**NOTICE OF DECISION TO CONSENT TO CHANGE TO PROPOSAL DURING
ASSESSMENT**

Bunbury Outer Ring Road (Northern and Central Sections)
Assessment No. 2215

**STATEMENT OF REASONS CONSENT TO CHANGE PROPOSAL DURING
ASSESSMENT**

Figure 1: Development envelope showing proposed changes

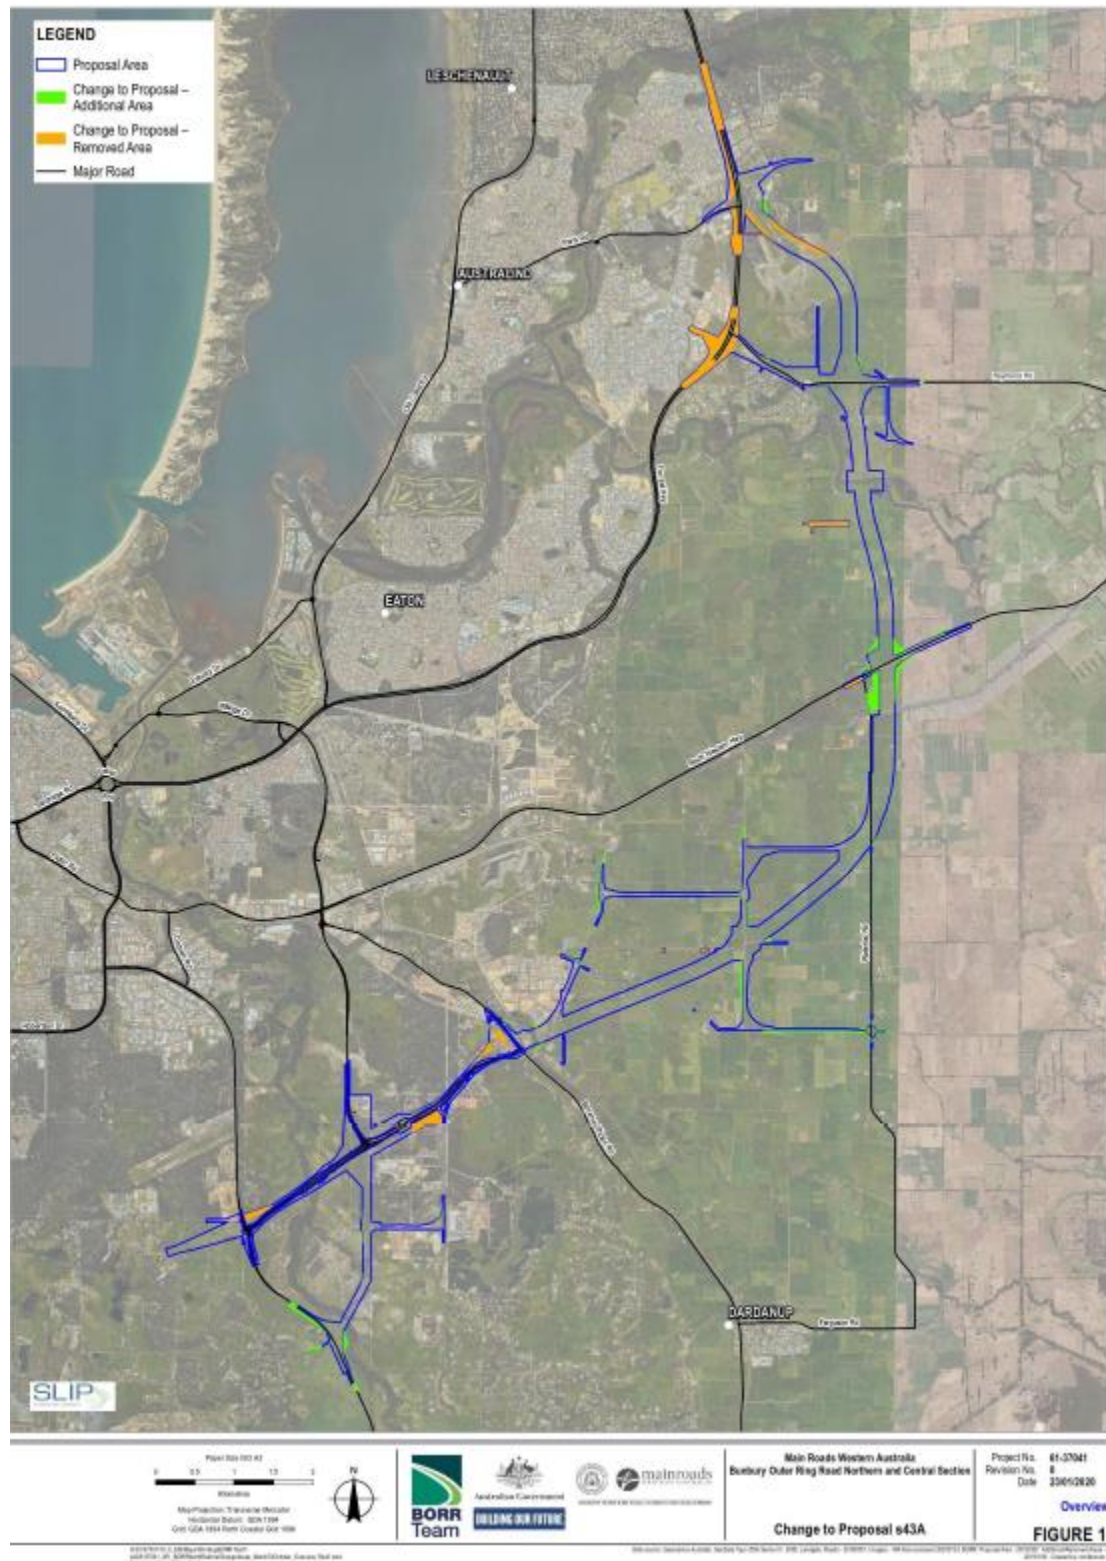
In advance of the EPA preparing a report on the outcome of its assessment of the Proposal, the Proponent has sought the EPA's consent to the proponent changing the Proposal. The s43A change would result in a 26 ha decrease in the development envelope from 651 ha to 625 ha (Figure 1).

The changes will result in an overall decrease in the extent of the development envelope from 651 ha to 625 ha. The key changes to the development envelope are decreases in the extent of the proposal at the intersections of Forrest Highway and Paris Road, the interchange at Raymond Road, and between the Boyanup-Picton Road and the southern South Western Highway interchanges. Minor increases in the extent of the development envelope are proposed at the northern intersection with the South Western Highway and at the South Western Highway near the Preston River.

Amendments to the design, construction and alignment of the proposal resulting in a 26 hectare (ha) decrease in the development envelope from 651 ha to 625 ha (refer Schedule 1).
